Access Compliance Report

Public Rights-of-Way

(Curb Ramps)

Intersection ID: 17742	Main Street: S_WENDOVER_RD	Cross Street: PROVIDENCE_RD	Location: SW
ADA ID: 05B301E704D1	Ramp Type: BlendTrans2	Initial Pass/Fail: Fail	Overall Compliance: No
		Severity Score: 8.75

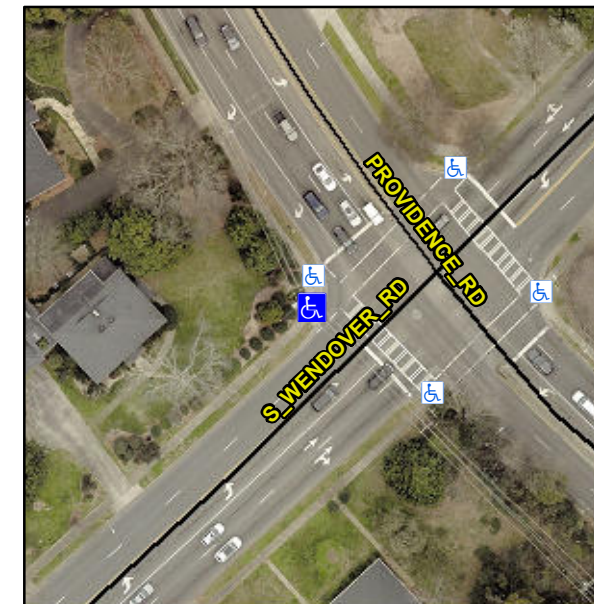
R304.5.1

Remove & Replace Curb Ramp With Two New Directional Ramps or Equivalent. Restripe Crosswalk.
